Safety Evaluation Report
McGuire Nuclear Station: Units 1 and 2
Proposed Technical Specifications

The Proof and Review copy which has been reviewed by RSB comprises a Westinghouse Standard Technical Specification, Revision 4, which has been marked up by the Licensee as a proposal for Units 2 (and 1). This mark up was further reviewed by SSPB for conformance to the Westinghouse Standard Technical Specifications, and, by mutual agreement between the Licensee, NRR/DL and SSPB, subsequent changes have been made. This subsequent document presented to RSB for review, contains no record of, or, safety evaluation reports on, these changes which have been made including any relationship to the existing McGuire Unit 1 Technical Specification and the Final Safety Analysis Reports, or the Safety Evaluation Reports, for McGuire Units 1 & 2.

Plant Name:	McGuire Nuclear Station, Units 1 and 2
Docket Number:	Unit 1, 50-369; Unit 2, 50-370
Licensing Stage:	Unit 1-OR; Unit 2-OR
License No.:	Unit 1, NPF-9; Unit 2, NPF-17
Responsible Branch:	Licensing Branch #4
Project Manager:	Ralph A. Birkel
Review Branch:	Reactor Systems Branch
Review Status:	Complete with need for confirmatory <i>open items.</i>

FIGURE 2.1-1
REACTOR CORE SAFETY LIMIT - FOUR LOOPS IN OPERATION
* Under Anticipated Gross Level Disturbances

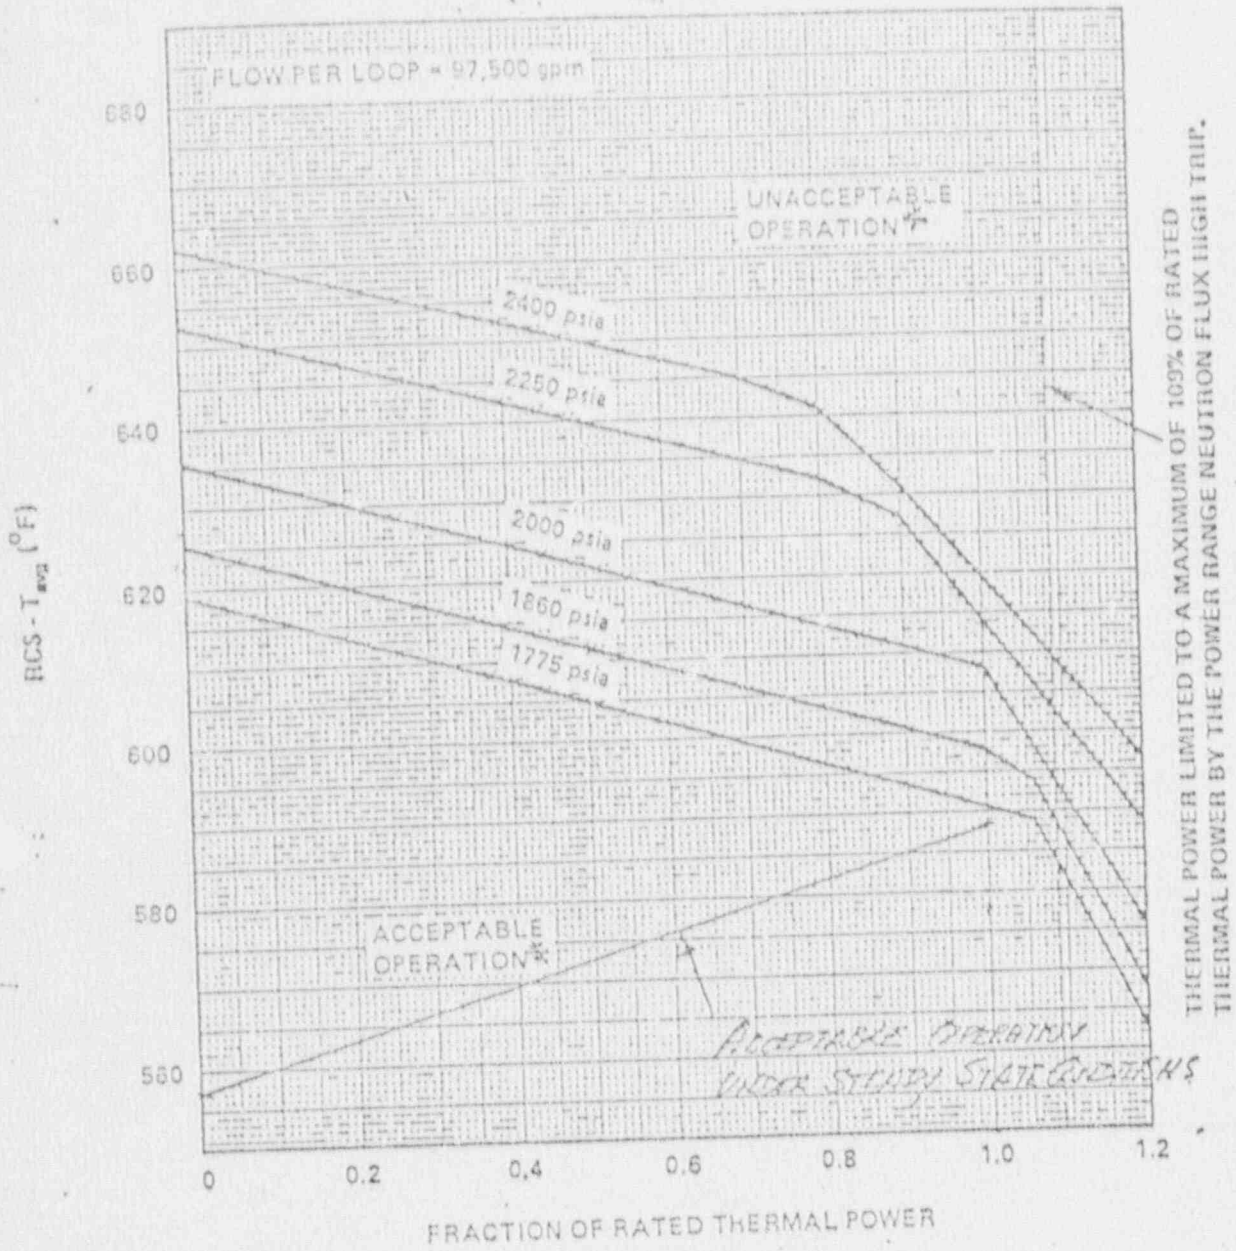
T.S. Pages 2-1, 2: It is necessary to emphasize that the "acceptable (region of) operation" in Fig. 2.1-1 does not represent an allowable region of Steady State Operation for the reactor core; that actual steady state operation is confined to a very narrow band of operation on the Figure so that the Safety Limits shown are not exceeded under Anticipated Operational Occurrences.

TABLE 3.2-1

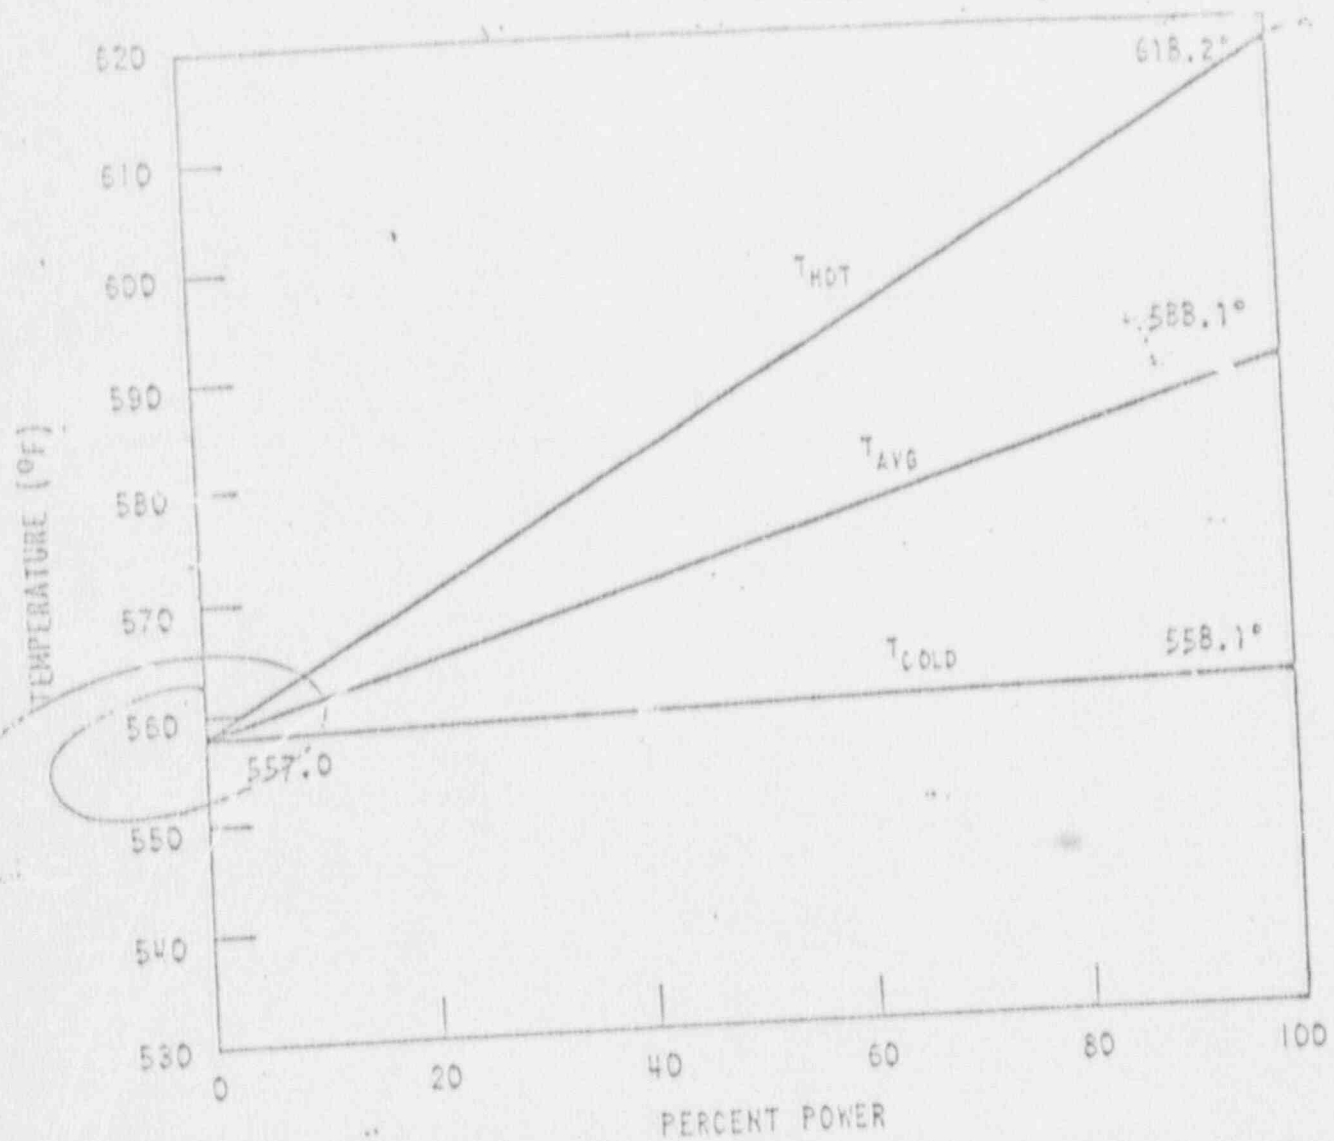
Values in Table 3.2-1 should be given as indicated (Setpoint) values. Table 3.2-1 shows marked differences from Reference 20, figure 5.3.3-1. These differences must be resolved.

Presumably these are Control Room Instrument Values
 ∴ they must be the normal setpoint values for
 Programmed Tag out, NO LOAD and RATED POWER
 levels and the normal system pressure of 2235 psig
 which have been the standing before the ACCIDENT EVALUATION

There is need to clarify apparent ambiguities on the 0% RIT level.
 The T_{avg} is approx 551°F, Fig 3.3-1 of FSAR says 557.0°F
